CITY PLANNING COMMISSION
1231 "I" STREET, SUITE 200, SACRAMENTO, CA 95814

APPLICATION: Special Permit Modification to add 30 apartment units to an existing 250 unit apartment complex on 10.5± acres in the Multi-Family Planned Unit Development (R-3 PUD) zone.

LOCATION: 7767 La Riviera Dr.

PROPOSED SITE PLAN - W/ NEW 90° PARKING
 SCALE: 1" = 40'
 DATE: 5-9-91

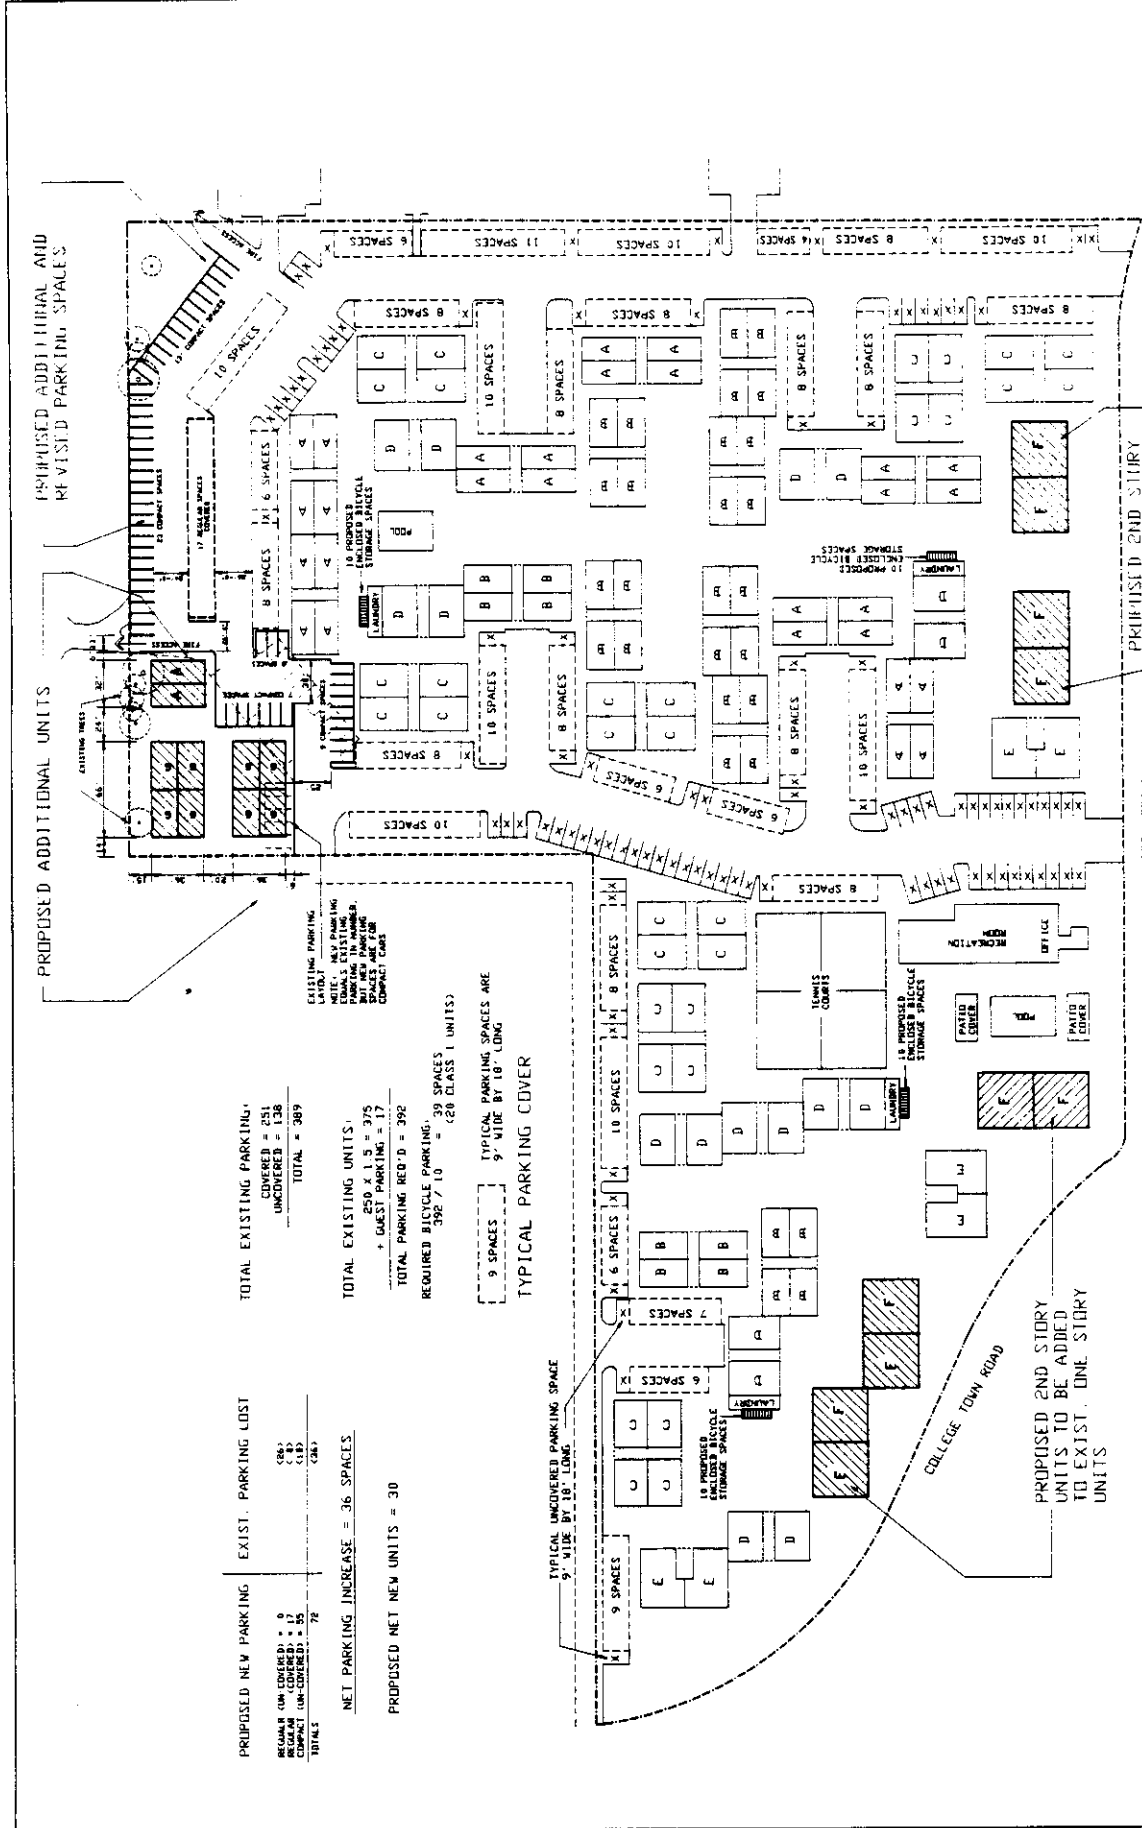
The applicant proposes to expand the parking area by eliminating a landscaping strip on the westerly portion of the lot. There is approximately 20± feet of landscaping between the apartments to the west and the parking area. Two fire access lanes are existing in this area and will remain. By eliminating the 10± feet of landscaping along the west property line the applicant will be able to provide 21 parking spaces. Staff recommends the applicant provide a finger planter for every 10 parking stalls provided in this area. This will improve the aesthetics by providing a break in the row of parking spaces in this parking area. In providing these finger planters two parking spaces will be eliminated. Staff recommends adding additional trees in the triangular area in the northwest corner of the site. This will allow for additional shading of the parking area as well as enhancing the view of the area. The site plan further indicates a reconfiguration of 11 parking spaces to compact spaces providing 19 parking spaces just east of the proposed units. Additional parking may be provided by restriping the entire parking lot to allow for 40 percent parking.

1. Minimum fire access is 20 feet.
2. Show existing compact space ratio. The entire site shall not exceed 40 percent compact spaces.
3. Proposed redesign of parking facilities. Does not provide minimum turning radius for fire access.

1. The units shall be built per the submitted plans.
2. For every 10 parking spaces a finger planter shall be provided for the new parking provided along the west property line. The planter area shall be irrigated and planted with a tree and living ground cover.
3. Additional trees shall be provided in the triangular area in the northeast corner of the site subject to Planning staff review and approval prior to issuance of building permit (see Exhibit C for location).
4. Additional evergreen trees shall be planted along La Riviera Drive per exhibit C.
5. The parking layout shall be subject to review and approval of the City Traffic Engineer and the Fire Department prior to issuance of building permit.
6. The applicant/owner shall comply with the mitigation measures identified in the Negative Declaration P91-057.

PROPOSED SITE PLAN - W/ NEW 90° PARKING
 SCALE 1" = 40'

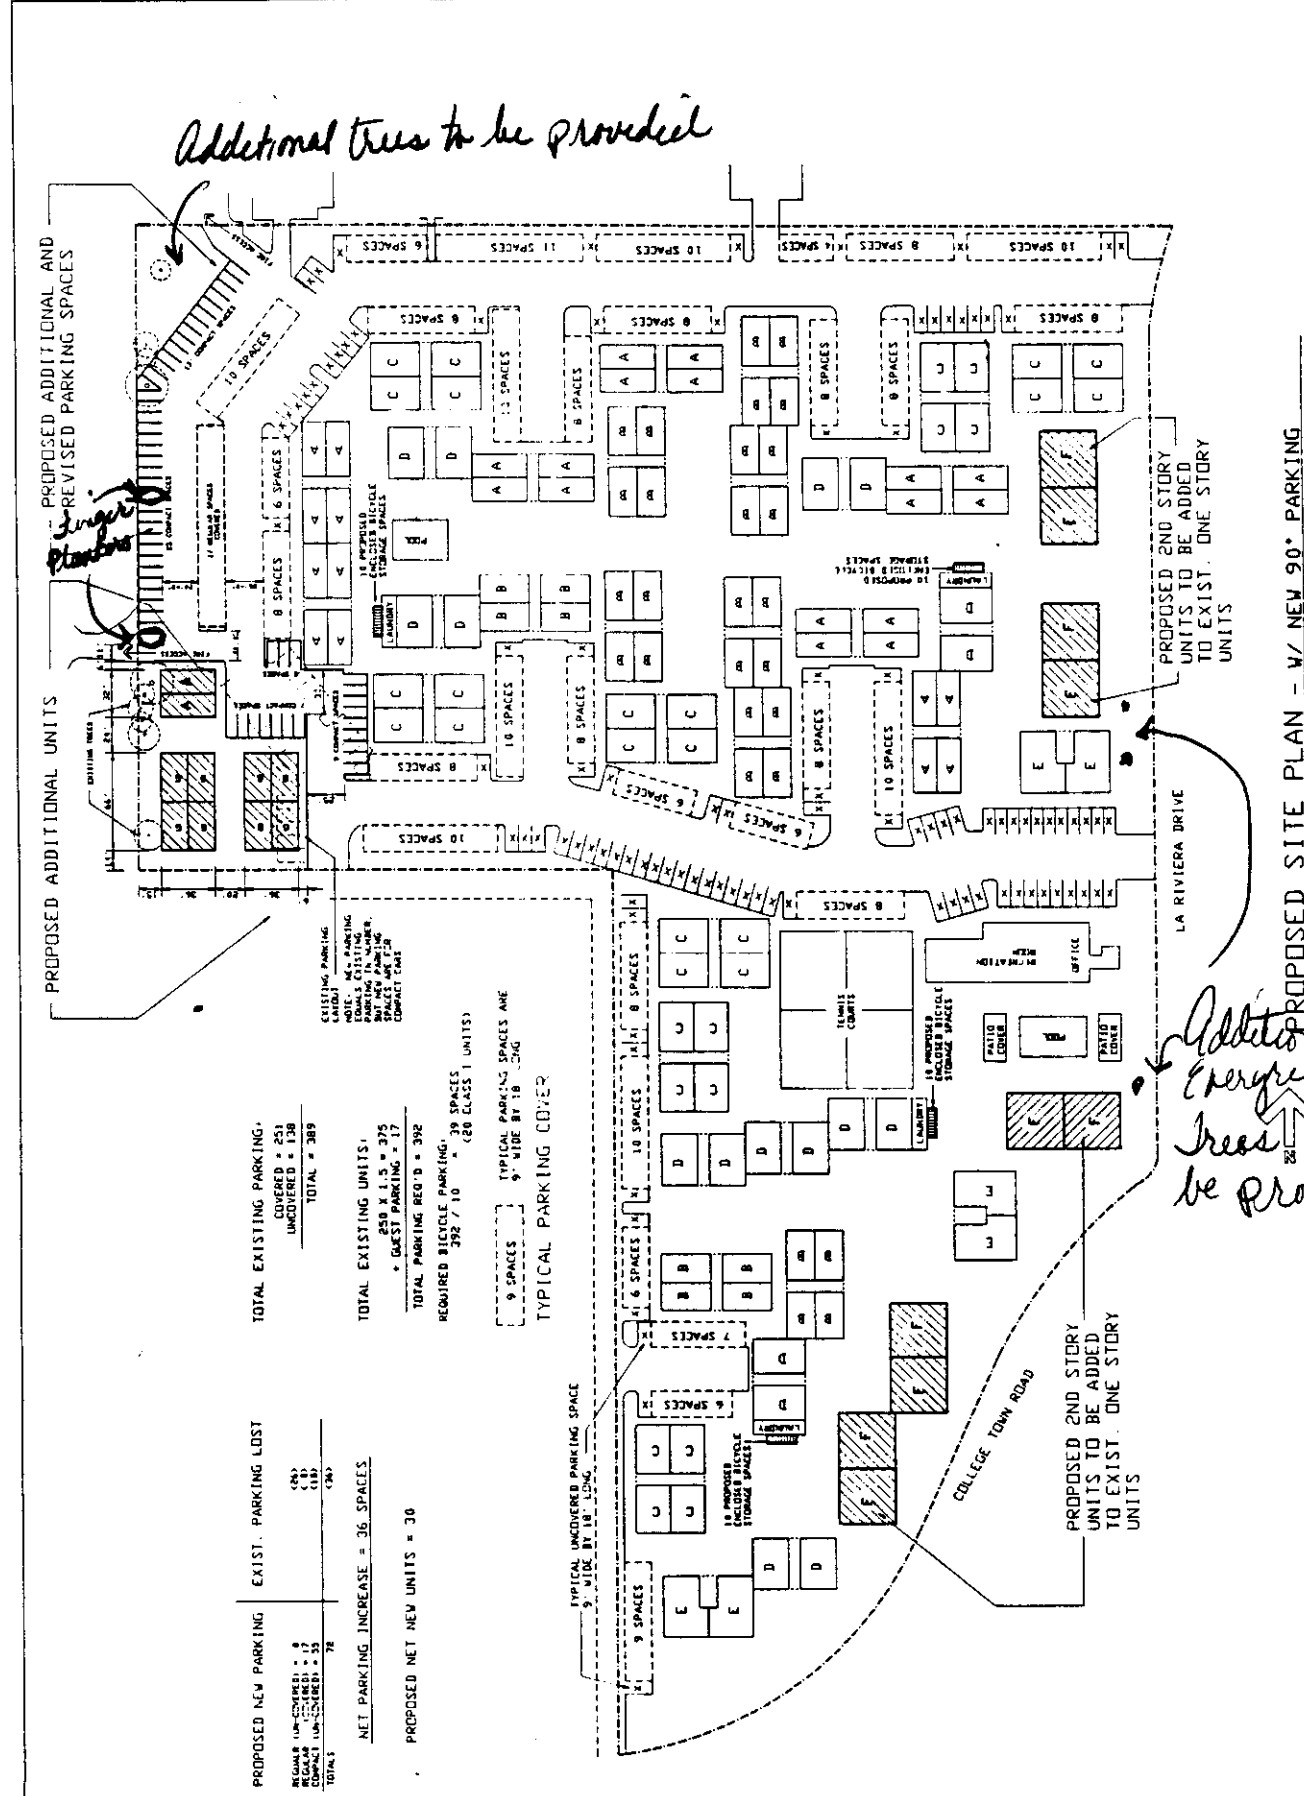
Additional trees to be provided

Additional Evergreen trees to be provided
